Immaculate Conception CES New Universal Washroom

ADDENDUM #1

Project No: 25223

Project: Immaculate Conception Universal Washroom
76 Robinson St.

DO NOT SCALE THE DRAWINGS.
CHECK AND VERIFY ALL DIMENSIONS AT THE SITE.

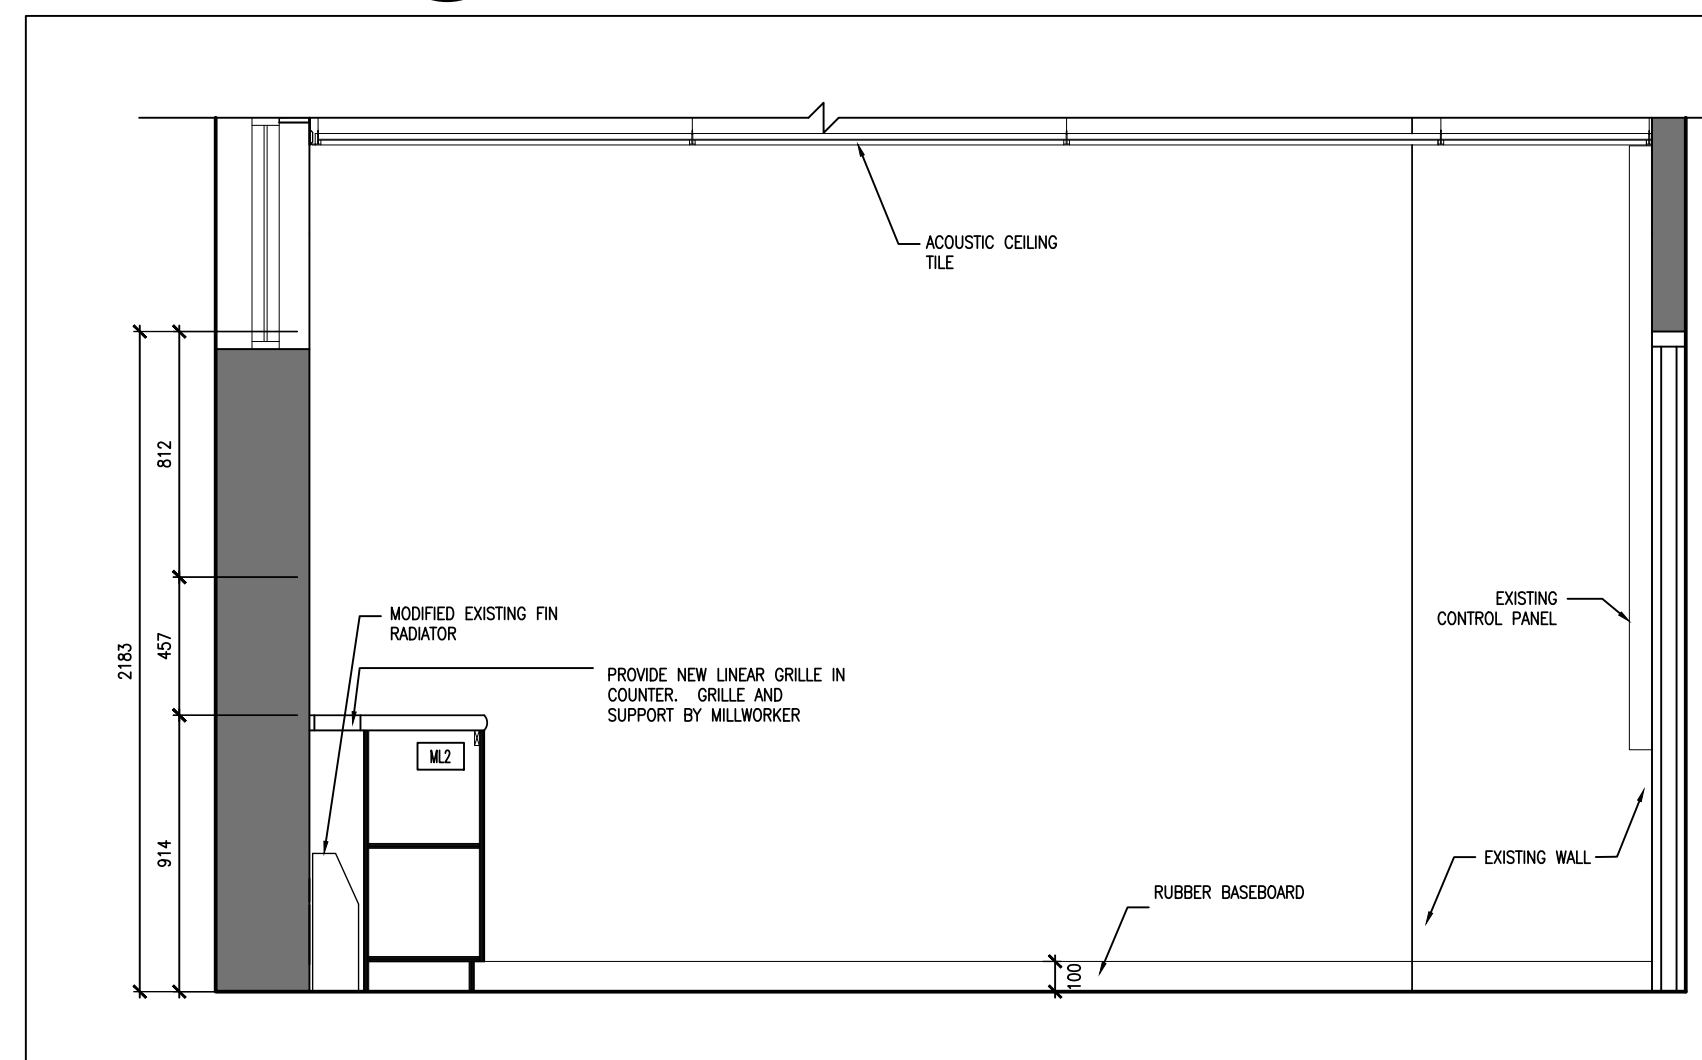
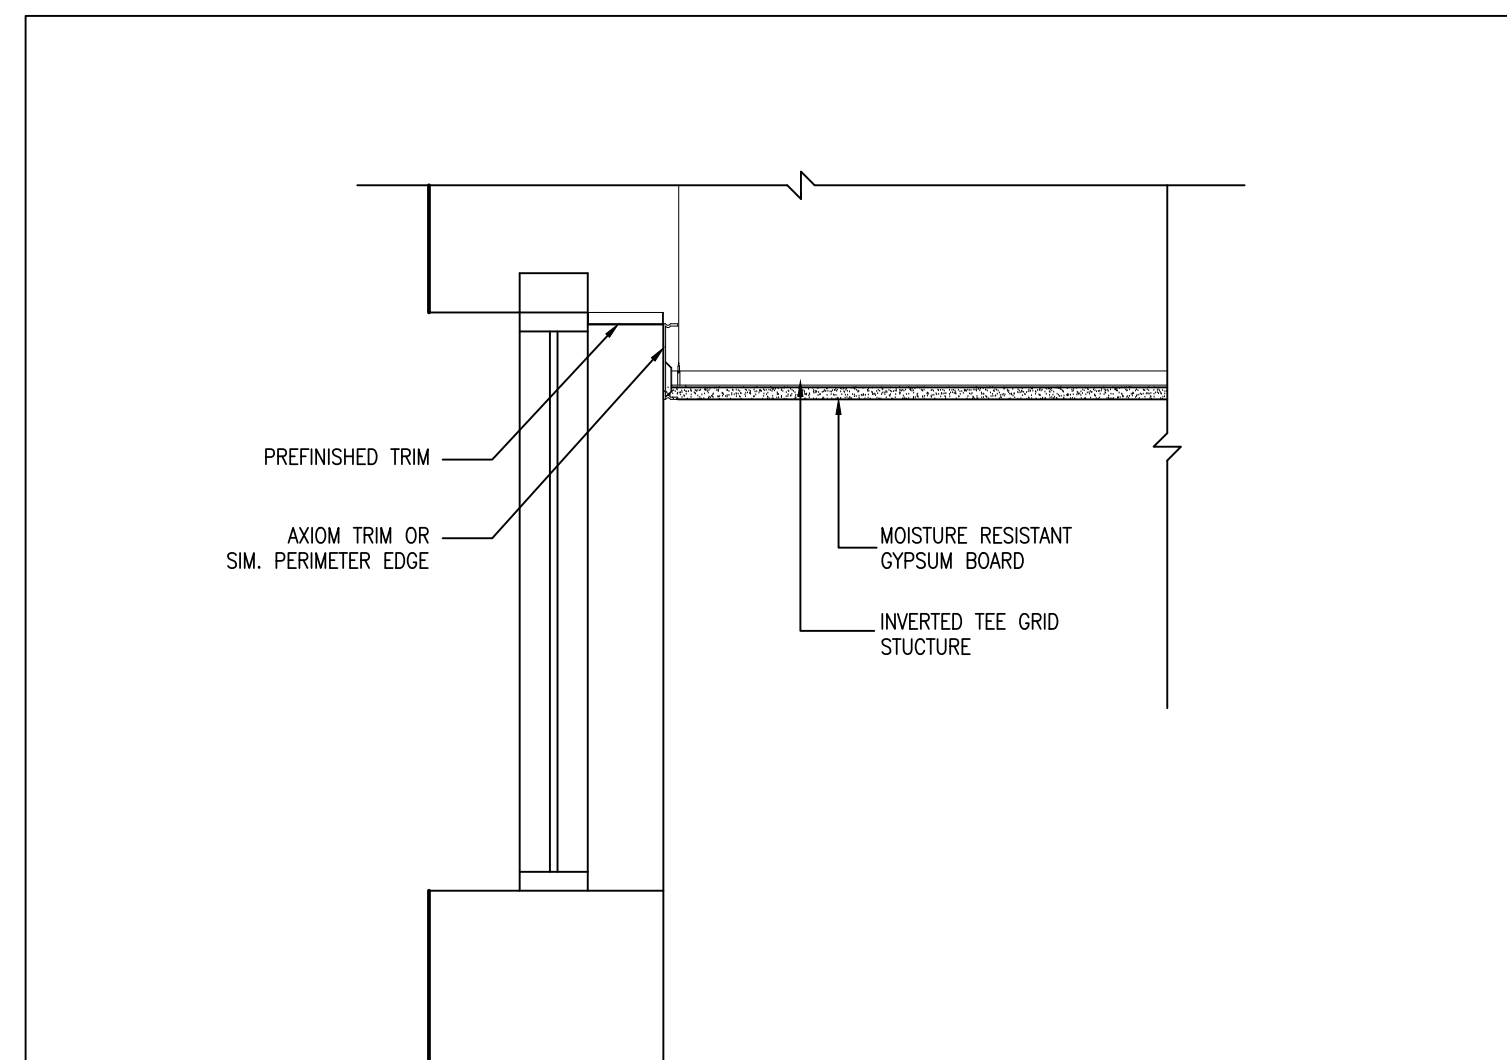
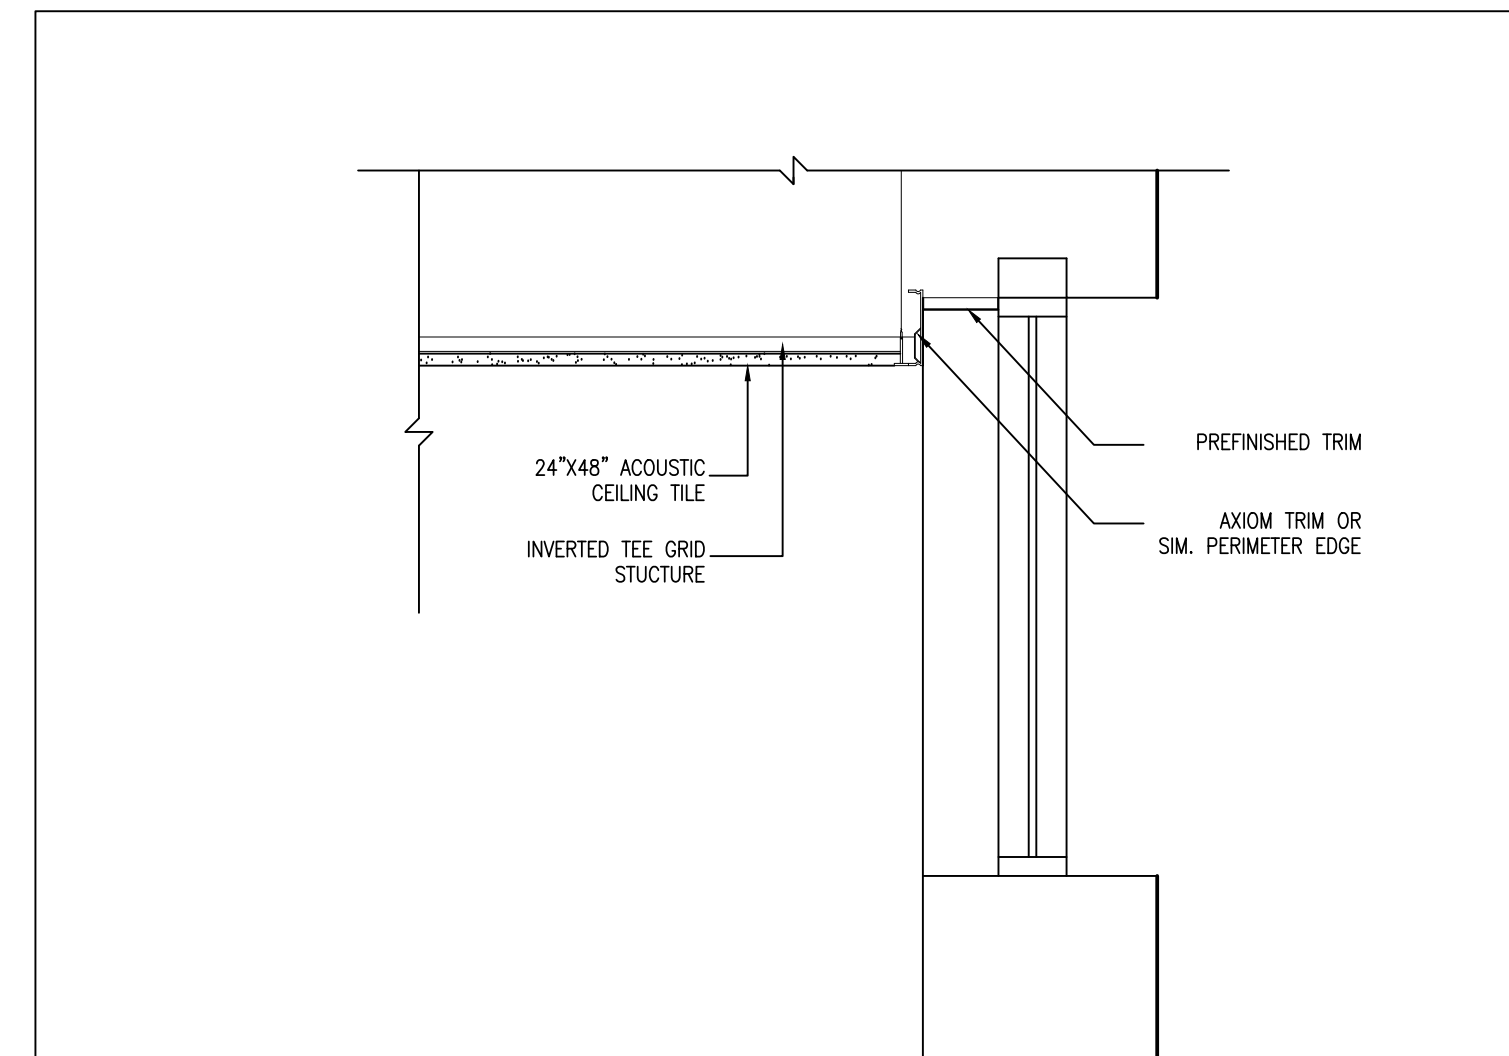
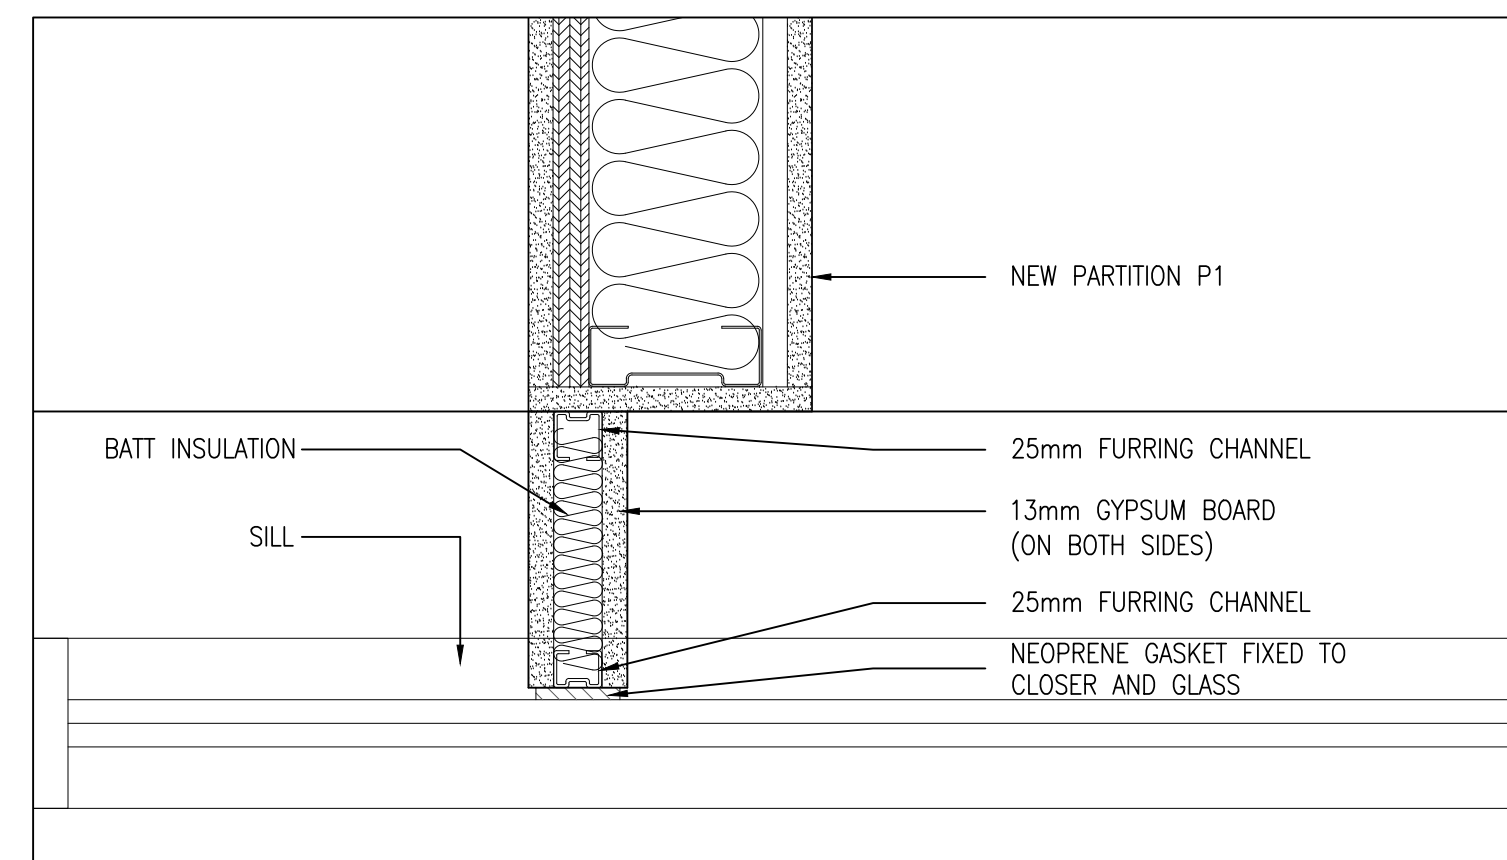
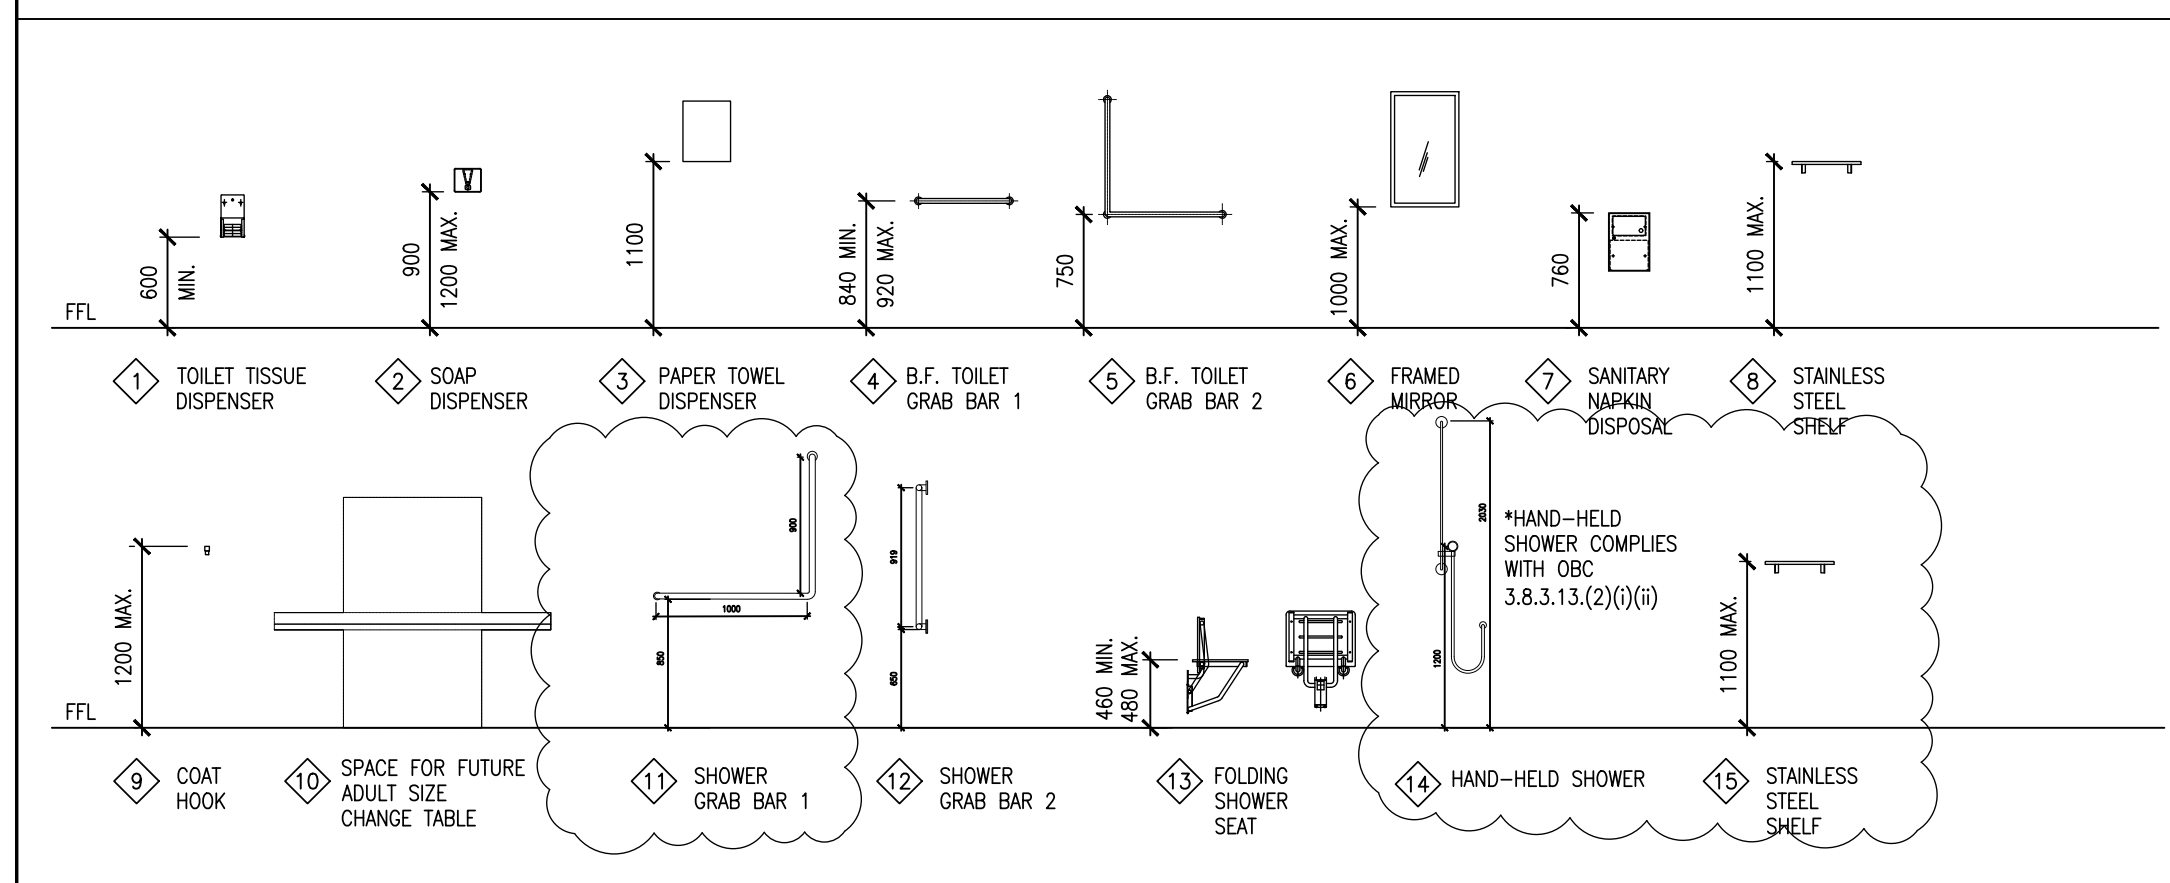
Question 2: 1. Detail 8/A701 shows batt insulation at P1 assembly, but it is not noted in the assemblies. Can you please confirm that we should include batt insulation
2. Division 9 specifications note that walls are to use 6 inch steel studs but the assemblies note 3 5/8 steel studs. Can you please confirm which item we are to carry?

Answer 2: .1 Confirmed to utilize comfort batt within the P1 wall assembly
.2 Confirmed to utilize 92mm studs as noted on the wall assemblies.
